A G E N D A
CITY OF POCATELLO
PLANNING & ZONING COMMISSION MEETING
JANUARY 8, 2025 • 6:30 PM
COUNCIL CHAMBERS | 911 N. SEVENTH AVENUE

**PLANNING & ZONING COMMISSION
MEETING JANUARY 8, 2025
STAFF REPORT**

PROJECT:	Aspen Place PUD	FILE # PUD24-0002
APPLICANT/OWNER:	David Assan of Sunrise Engineering -representing Gate City Builders	
SURVEYOR/ENGINEER:	Matt Baker of Sunrise Engineering	
REQUEST:	Planned Unit Development application	
TITLE REPORT:	Title report was submitted and reviewed	
LOCATION:	Four separate parcels located at 2806 S. 5 th Avenue	
STAFF:	Matthew G. Lewis M.S., Senior Planner

Re: Aspen Grove Apartments - P&Z Preliminary Plat (01.08.2025) Application #PP24-0004

PRELIMINARY PLAT FOR:
ASPEN GROVE SUBDIVISION

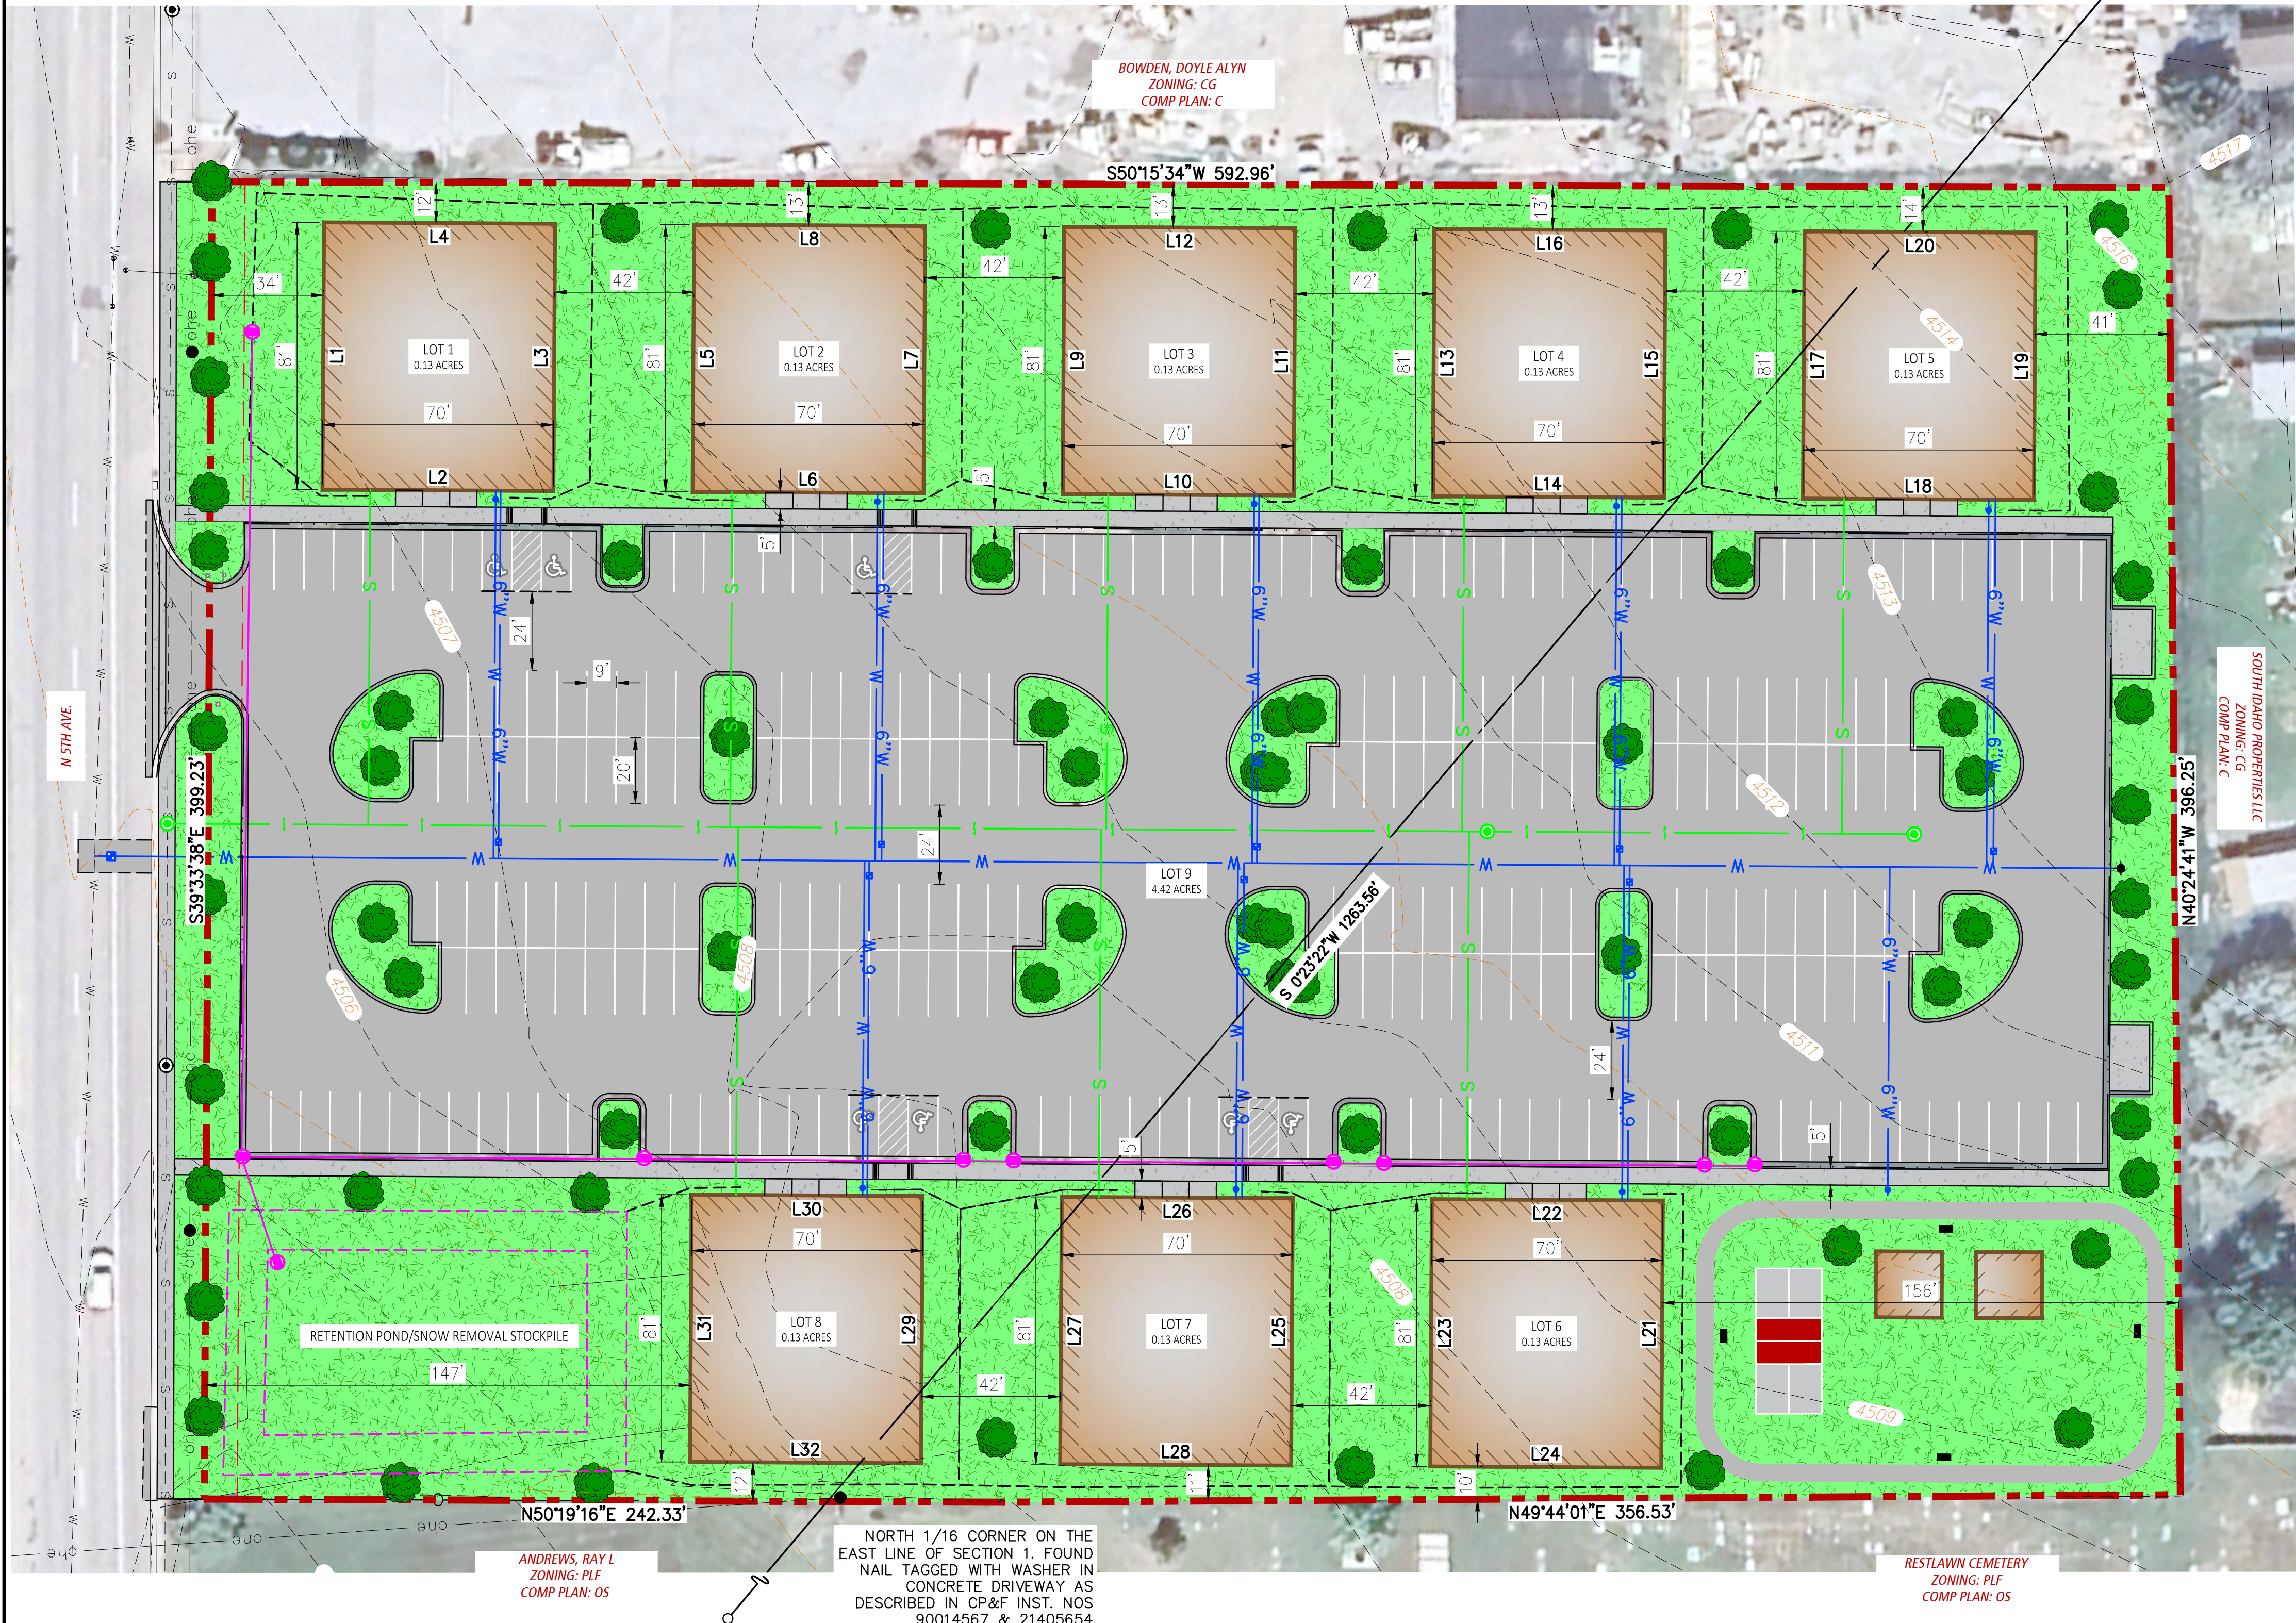
The Public Works Department has reviewed the preliminary plat application for the above-mentioned project and submits that the following changes and items shall be addressed prior to final plat application.

1. Switch the retention pond/snow removal stockpile area with Lot 1.
2. Confirm the center line of the proposed approach is lined up with the center line of Garden Street.
3. A street light shall be added at the proposed approach adjacent to S 5th Ave.

4. A traffic calculation and evaluation will need to be submitted at the time of final application.
5. Landscape trees adjacent to S 5th Ave. shall not incumber sight distance for a 35mph travel speed.

6. Add master meter size, vault and double check valve and vault location and detail to final plan set.
7. Calculations show there should be a minimum of 10 6-yard garbage dumpsters provided for this development. Dumpsters will be front load and require 60-90-feet of clear space for truck access.

8. The parking area shall be dedicated as shared common area and at no point may any gates or other obstruction be placed within the parking and access area so as to prevent fire access and garbage pickup through the parking lot areas. Fire access will be required to the rear yard of each townhome from the parking area.

9. Place a fire truck turning template for the drive isles within the parking area to insure adequate drivability.
10. Above ground communication line parallel to S 5th Ave. will need to be relocated underground through this development.

ATTACHMENT A
PRELIMINARY PLAT LAYOUT

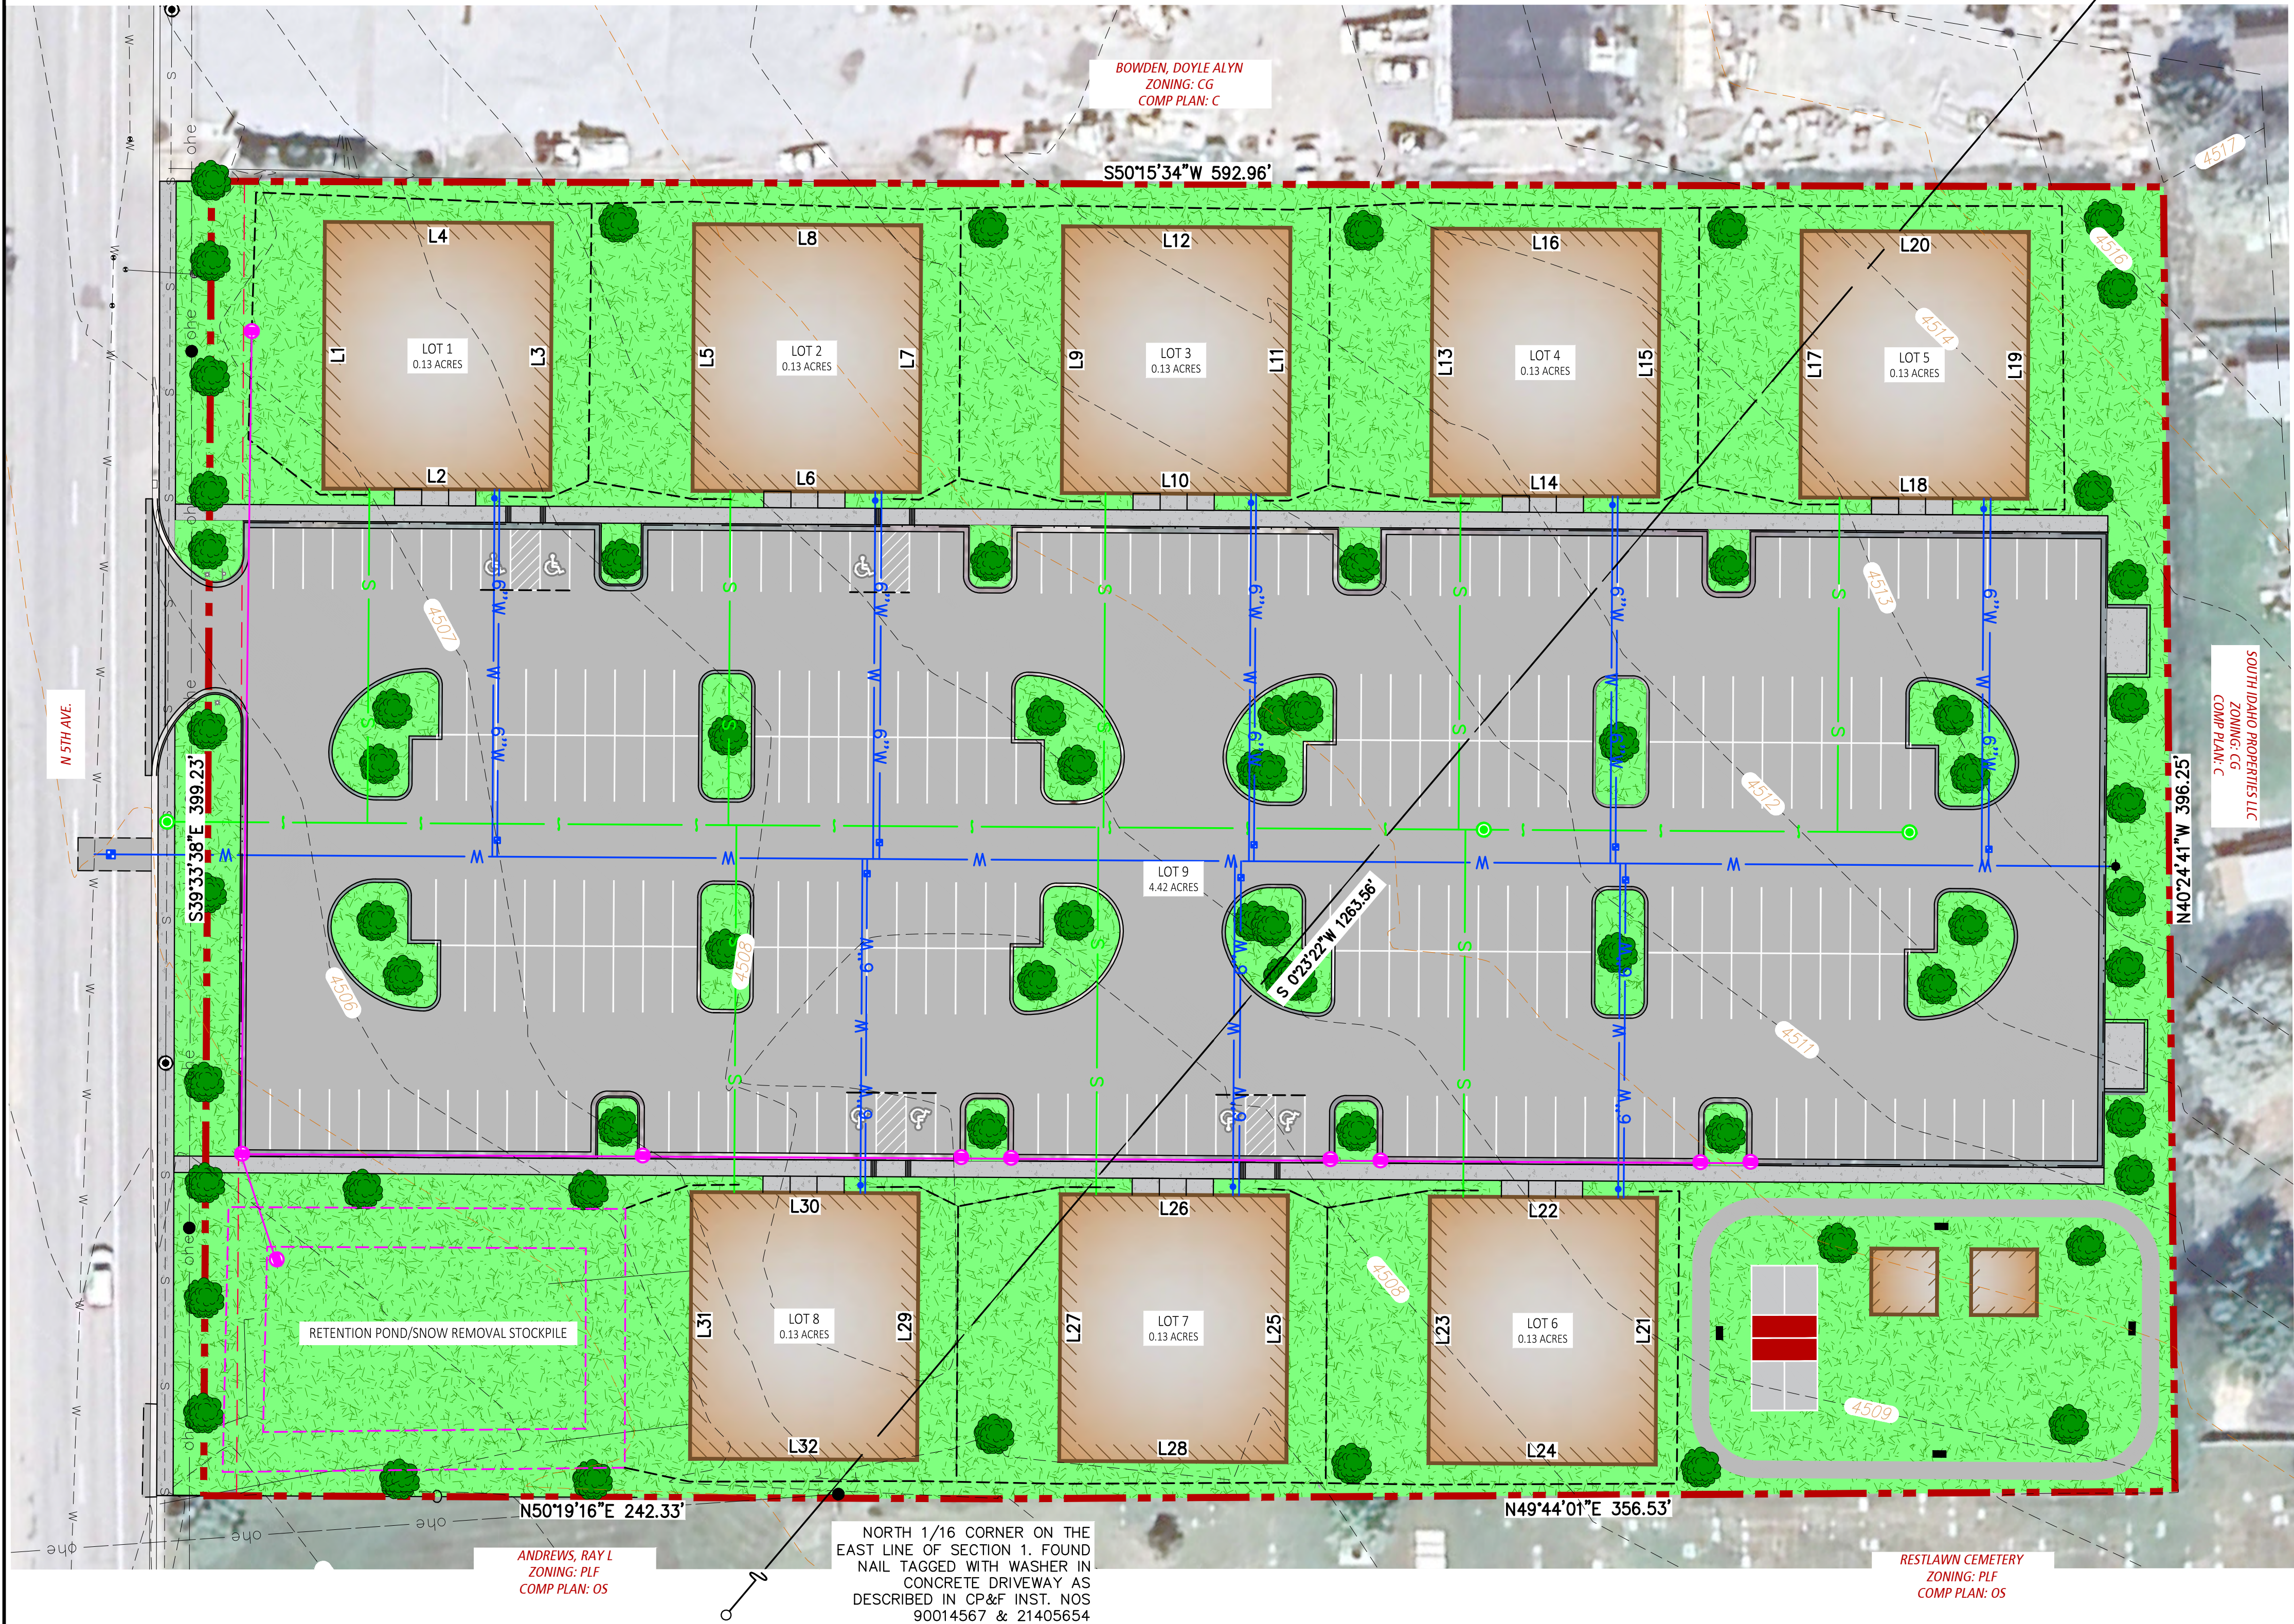
Staff finds that the proposal is compliant with all applicable standards of City Code 16.20.050, assuming the following conditions are met:

1. Per Pocatello Municipal Code Section 17.02.140D.3 states that subdividing of land may not proceed until a proposed PUD has been approved, the Final Plat shall not be submitted until the subject PUD has been approved;

2. The parking area shall be dedicated as shared common area and at no point may any gates or other obstruction be placed within the parking and access area so as to prevent fire access through the parking lot areas as well as the rear yard of each townhome.

3. A street light shall be installed on the north side of the approach.
4. Staff is recommending that an eight (8)-foot wide planter strip be provided between the curb and eight (8) foot wide sidewalk with a ten (10) foot landscaped setback provided on the east side of the sidewalk (as required by Municipal Code). In addition - one (1) tree a minimum of one & one-half inches (1.5") in caliper shall be provided for every thirty-five feet of street frontage in both landscaping areas. Such planting shall be staggered a minimum of ten 10-feet between trees within the landscape areas (Refer to Attachment D);
